# HISTORIC AND DESIGN REVIEW

March 06, 2019

**HDRC CASE NO:** 2018-007  
**ADDRESS:** 527 E HUISACHE AVE  
525 E HUISACHE AVE  
**LEGAL DESCRIPTION:** NCB 3090 BLK 6 LOT 26  
**ZONING:** MF-33,H  
**CITY COUNCIL DIST.:** 1  
**DISTRICT:** Monte Vista Historic District  
**APPLICANT:** David Bogle, R.A., AIA/SYNCRO Architecture Studio  
**OWNER:** Grant Garbo  
**TYPE OF WORK:** Construction of a rear addition, construction of front porch, exterior alterations, hardscaping and landscaping  
**APPLICATION RECEIVED:** February 06, 2019  
**60-DAY REVIEW:** April 07, 2019  
**REQUEST:**

2 Impervious Cover – Existing  
3/32" = 1'-0"

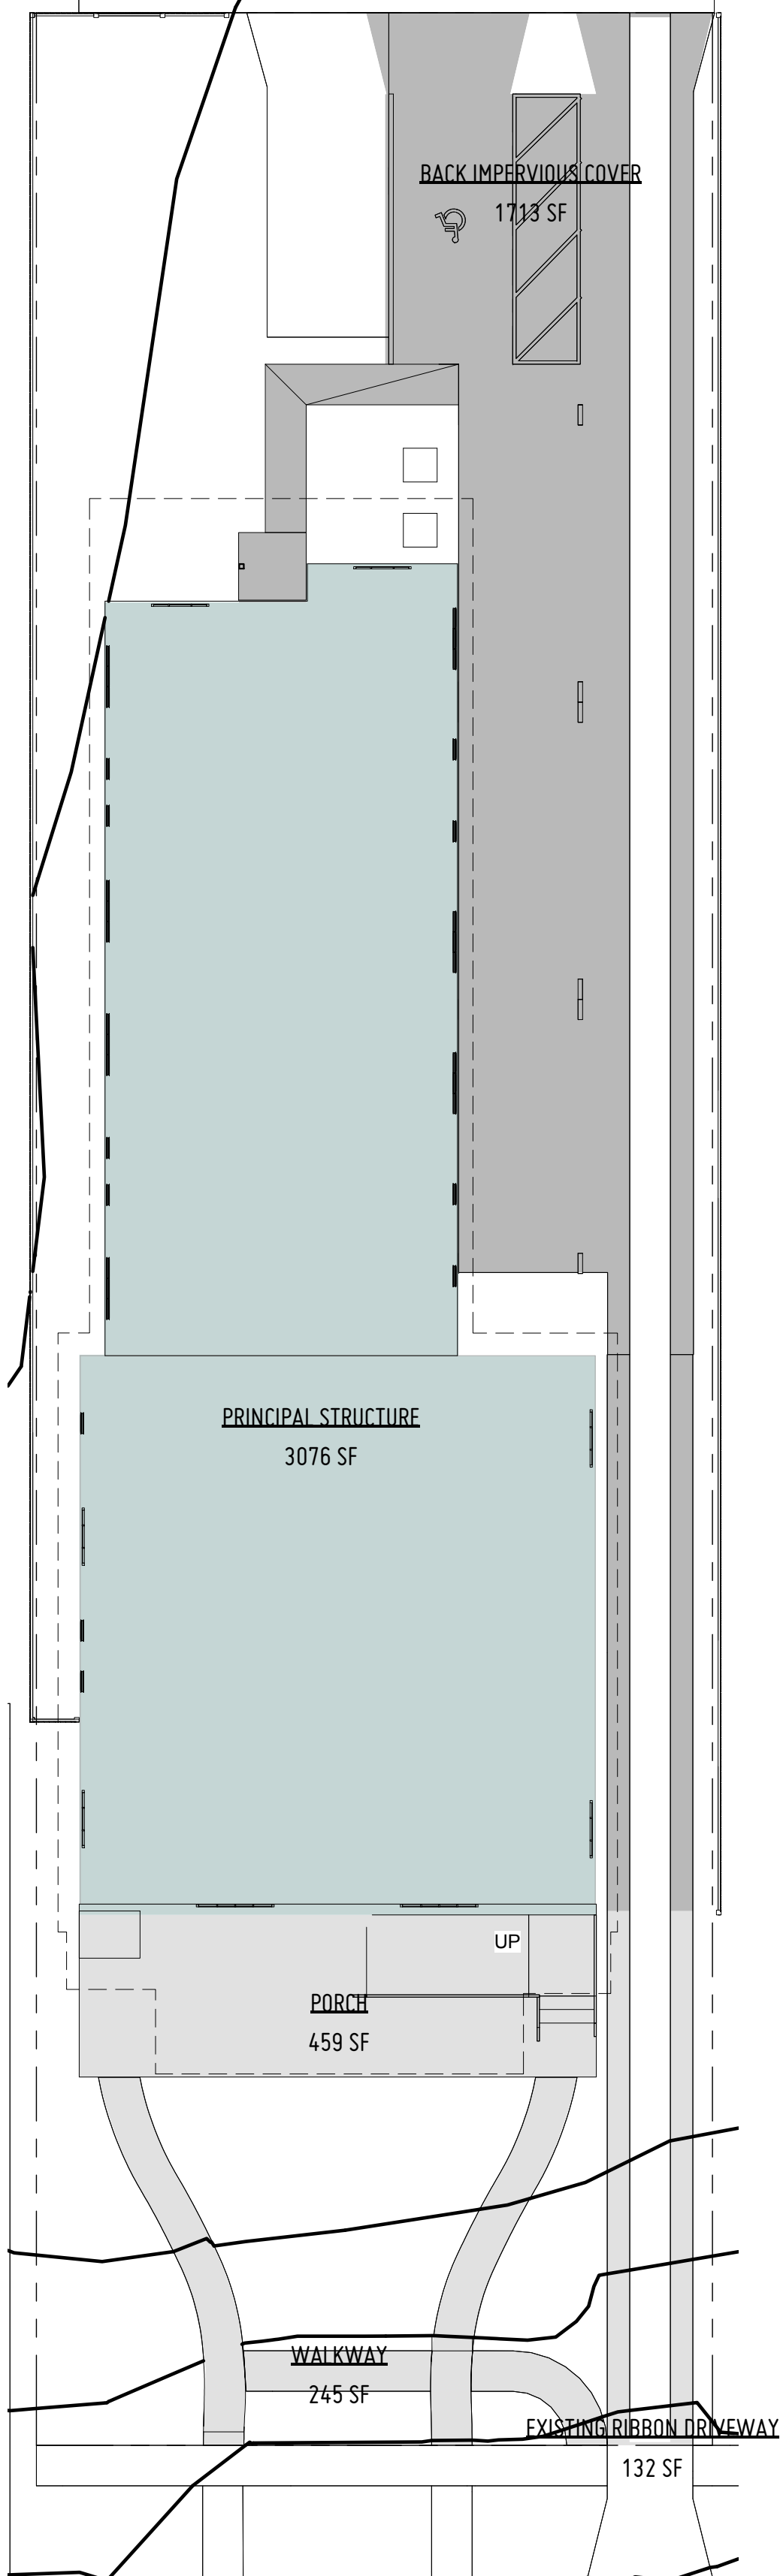
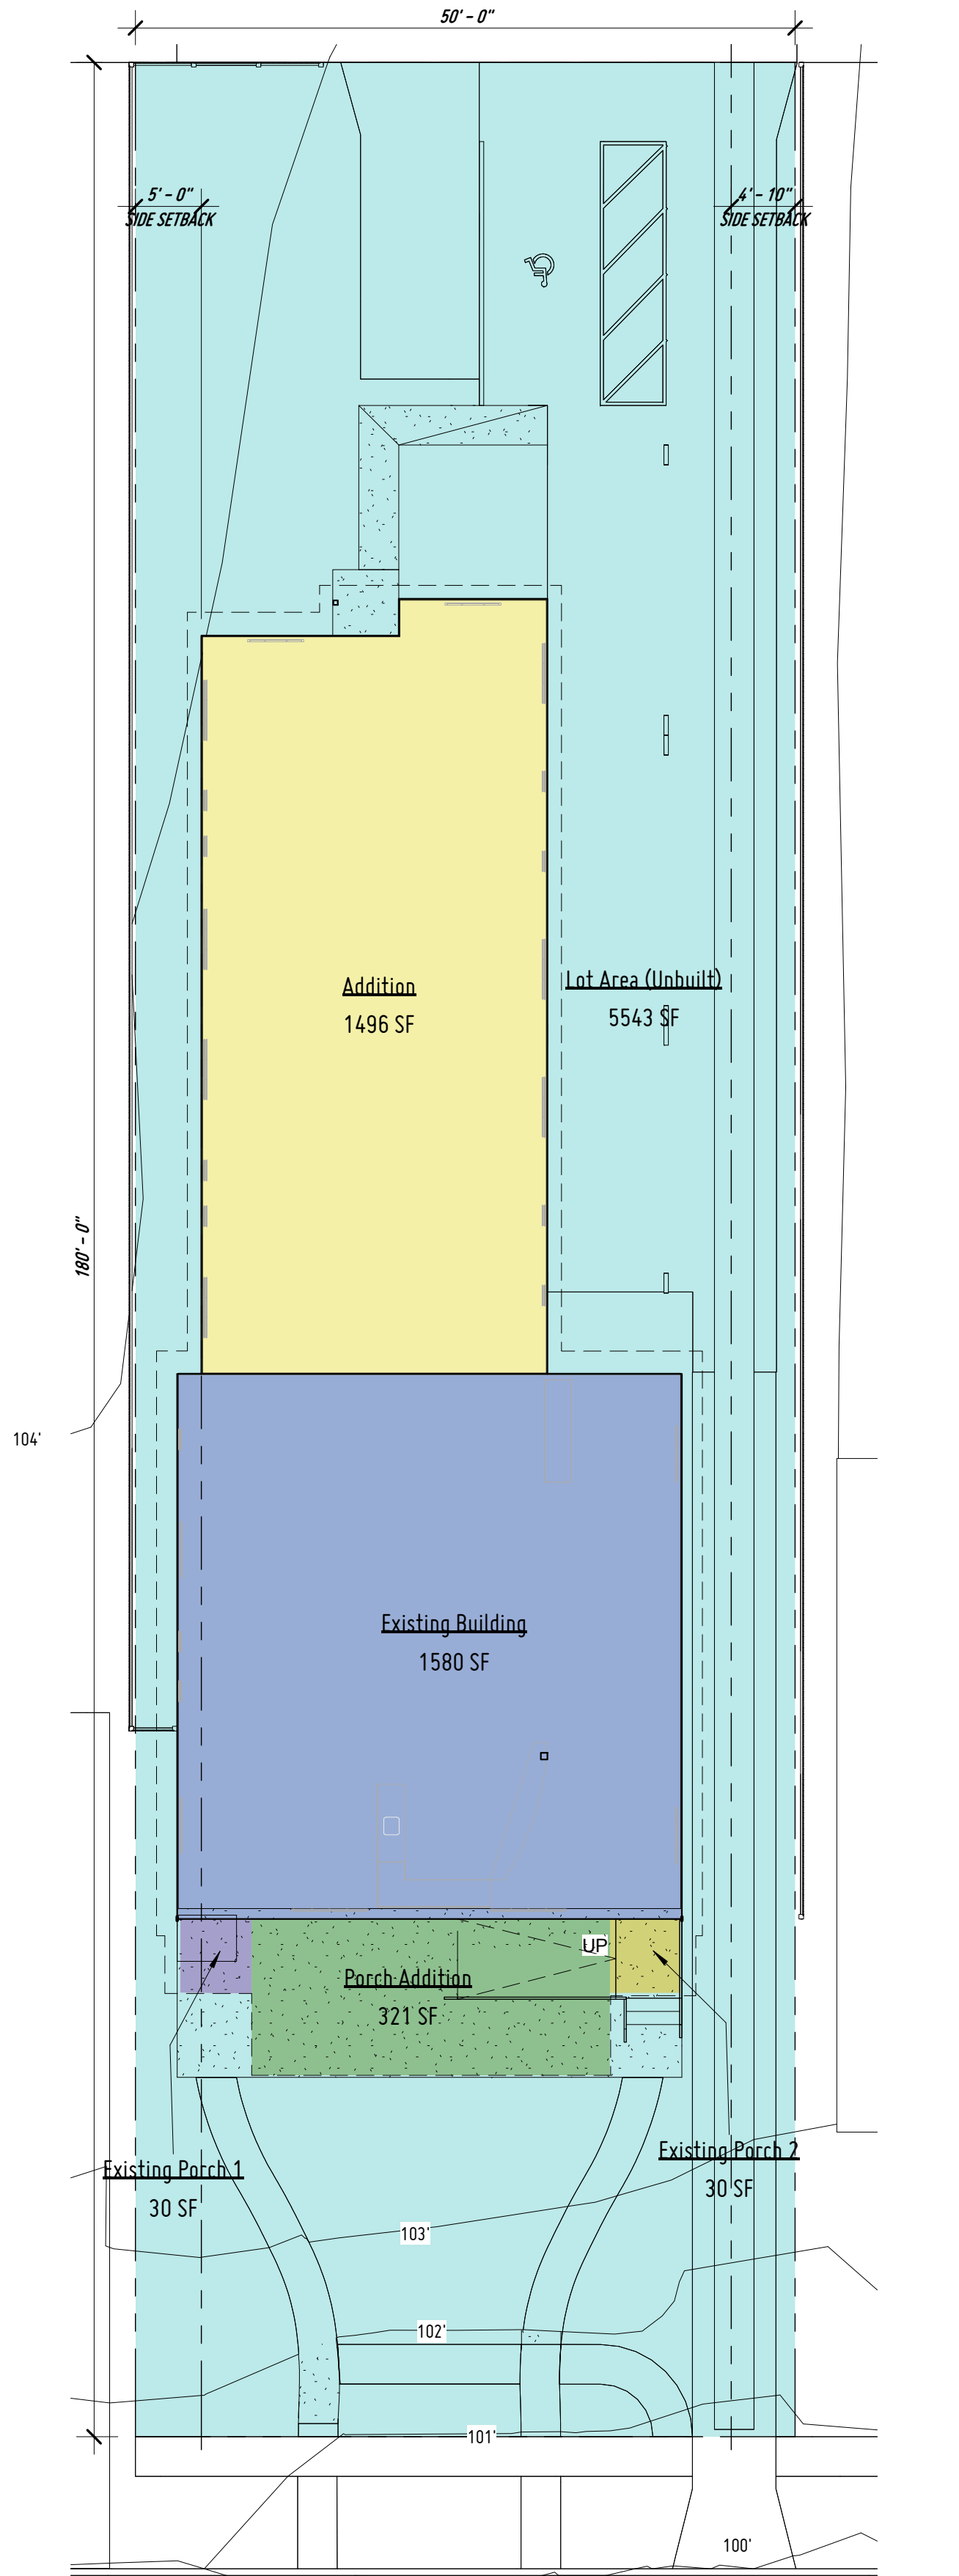
62%, which exceeds the recommended guideline of 50%. The applicant has indicated in their submission documents that the average percentage of impervious cover for residential structures in the vicinity is 42%, and the average for multifamily structures in the vicinity is 62%. While some properties on E Huisache, Kings Ct, and E Mulberry feature extensive hardscaping in the rear of the lot, the predominant development pattern for all structures is a rear yard with a majority grass or trees and other plantings with rear accessory structures or additions. Staff finds that the applicant should significantly reduce the amount of hardscaping due to the additional impervious changes proposed to the lot. The overall total of new introduced impervious cover, when considering both the addition and the hardscaping, is inconsistent with the Guidelines.

① Visibility Study – Street 1

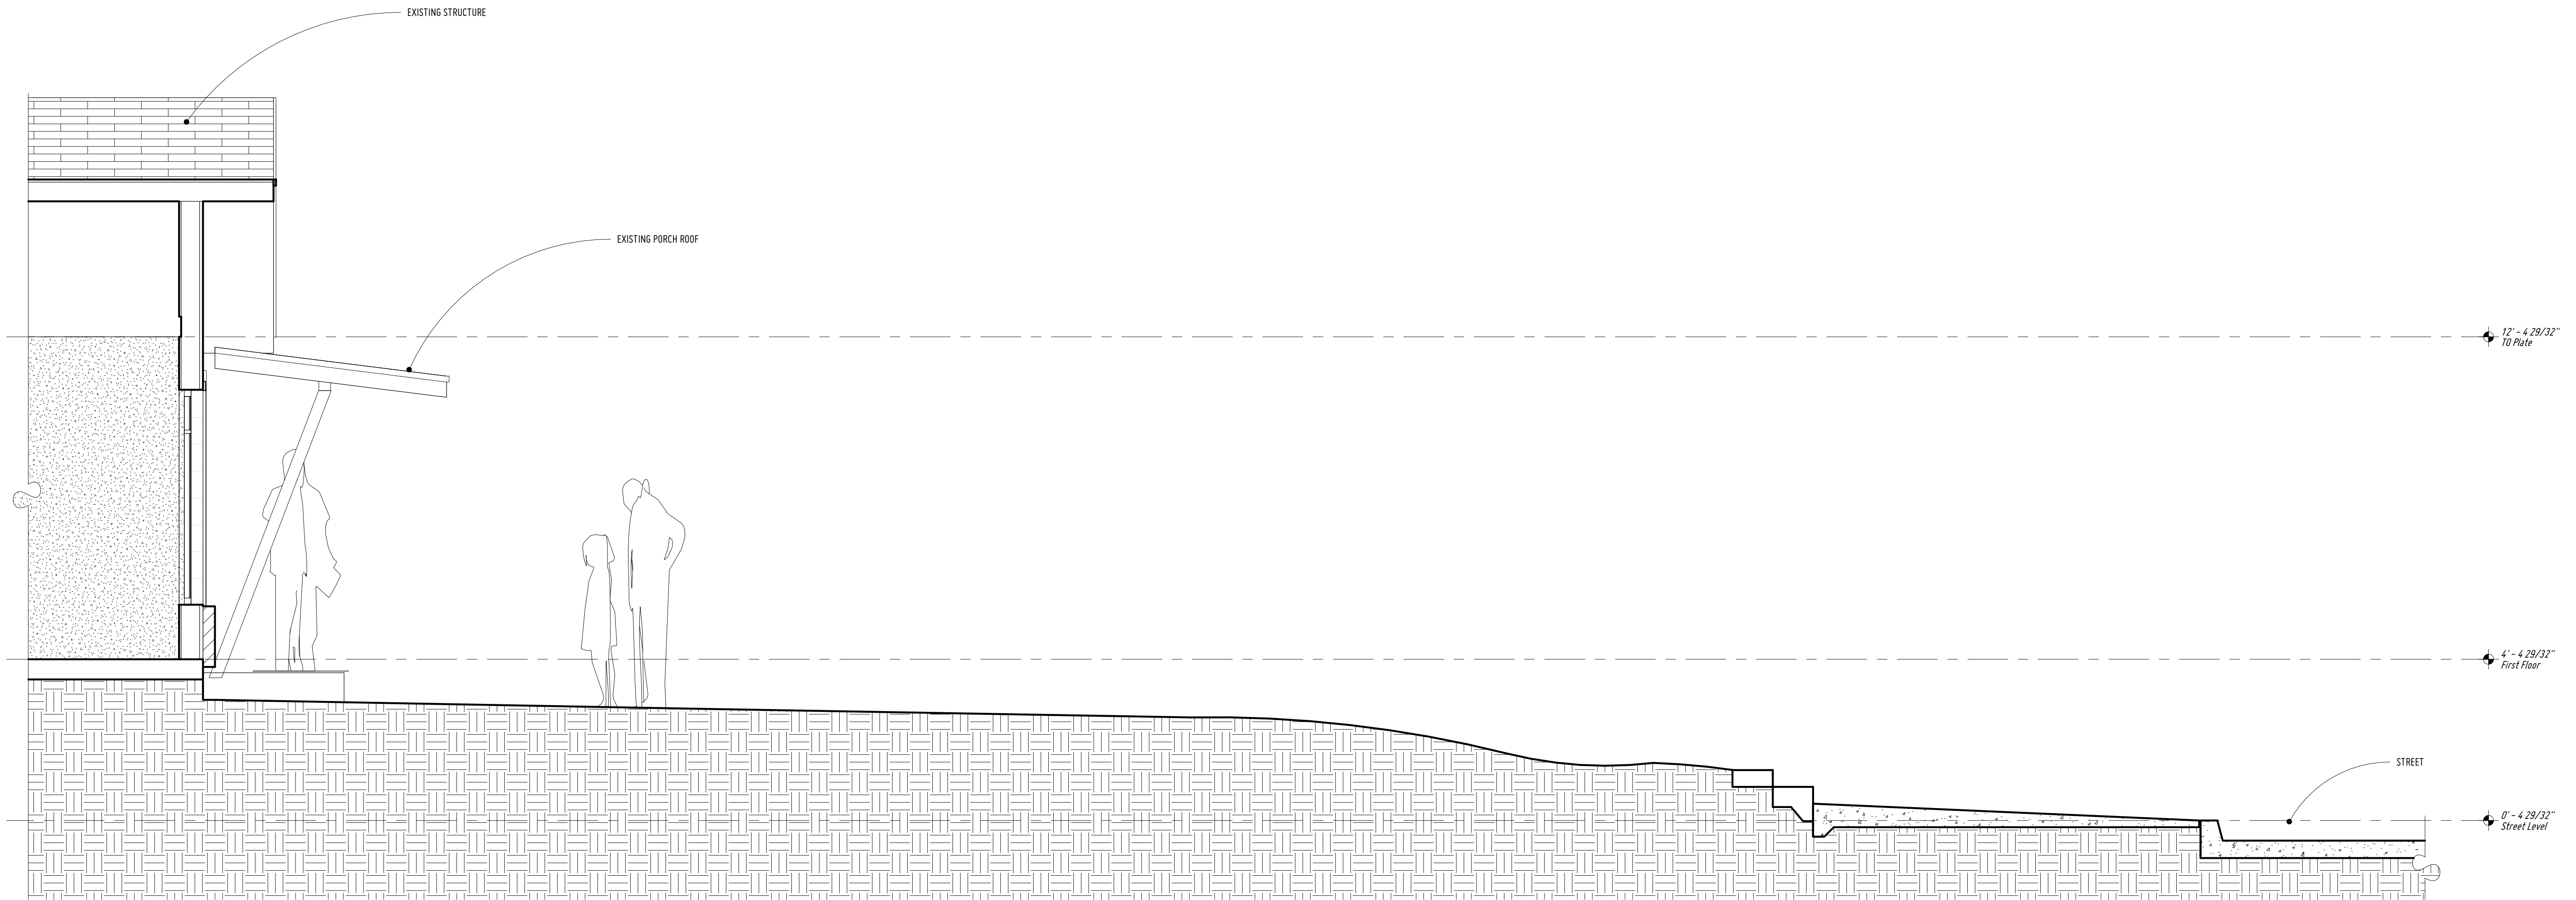
- i. **SKYLIGHTS** – The applicant has proposed to install skylights on the primary structure and on the rear addition, which was not included in the proposal for conceptual approval. Based on the submitted elevations, the skylights will feature a round profile and will protrude from the existing plane of either side of the gable. The skylights will be visible from the street. According to the Historic Design Guidelines for Exterior Alterations, new roof vents or roof elements should be located on rear roof pitches, out of view of the public right-of-way. There is no precedent in the vicinity for the primary roofline of a historic property to feature projecting skylight or venting elements. Staff does not find the proposal consistent with the Guidelines.

- v. That the applicant removes the proposed skylights from the primary structure as noted in finding i.
- vi. That the applicant provides detailed specification information for the proposed new windows as noted in finding k. Staff finds a wood or aluminum clad wood window to be most appropriate that meets the following stipulations: meeting rails must be no taller than 1.25” and stiles no wider than 2.25”. White manufacturer’s color is not allowed, and color selection must be presented to staff. There should be a minimum of two inches in depth between the front face of the window trim and the front face of the top window sash. This must be accomplished by recessing the window sufficiently within the opening or with the installation of additional window trim to add thickness. Window trim must feature traditional dimensions and architecturally appropriate sill detail. Window track components must be painted to match the window trim or concealed by a wood window screen set within the opening.
